Access Compliance Report

Public Rights-of-Way

(Curb Ramps)

Intersection ID: 10039790	Main Street: TOLLESON_AV	Cross Street: N/A	Location:	N
ADA ID: 7816D608FCC2	Ramp Type: Perp	Initial Pass/Fail: Fail	Overall Compliance: No	Severity Score: 12.5
Codes/Mitigation Info/Possible Solution		Field Measurements/Component Compliance

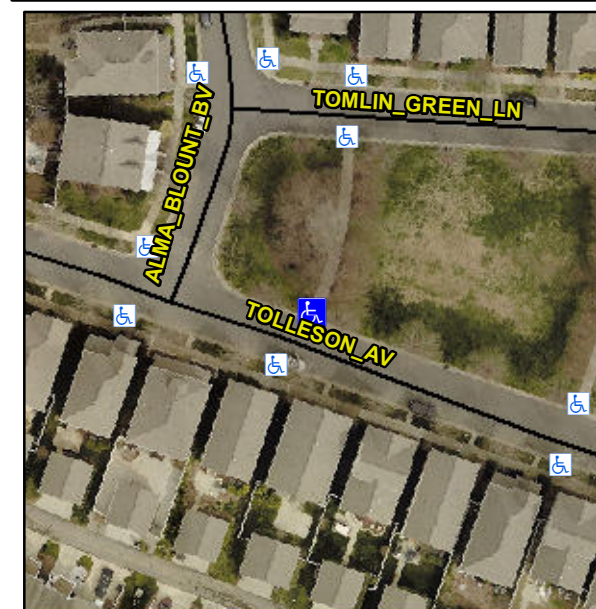
Not Found, R304.2.2

Compliance	Description	Data	Compliance	Description	Data
N/A	Ramp Length (in)	71.0	No	Ramp Slope (%)	9.0
Yes	Ramp Width (in)	71.0	Yes	Ramp XSlope (%)	0.4
N/A	Flare Type LT	N/A	N/A	Flare Type RT	N/A
N/A	Flare Slope LT (%)	N/A	N/A	Flare Slope RT (%)	N/A
N/A	Flare Traversable LT?	N/A	N/A	Flare Traversable RT?	N/A
N/A	Landing Length (in)	N/A	N/A	DWS Provided?	N/A
N/A	Landing Width (in)	N/A	N/A	DWS Contrast?	N/A
N/A	Landing Slope (%)	N/A	N/A	DWS Length (in)	N/A
N/A	Landing X Slope (%)	N/A	N/A	DWS Full Width?	N/A
N/A	Landing Curb? (Y/N)	N/A	N/A	DWS Offset (in)	N/A
N/A	Shared Landing?	N/A			
N/A	Gutter Ponding?	N/A	N/A	Gutter Slope (%)	N/A
N/A	Gutter Lip Ht (in)	N/A	N/A	Gutter X Slope (%)	N/A
N/A	Painted X Walk1?	No	N/A	Painted X Walk2?	N/A
	X Walk 1 Direction	To SW		X Walk 2 Direction	N/A
N/A	X Walk 1 Width (in)	N/A	N/A	X Walk 2 Width (in)	N/A
	X Walk 1 Slope (%)	1.5		X Walk 2 Slope (%)	N/A
	X Walk 1 X Slope (%)	1.1		X Walk 2 X Slope (%)	N/A

Remove & Replace Entire Ramp.
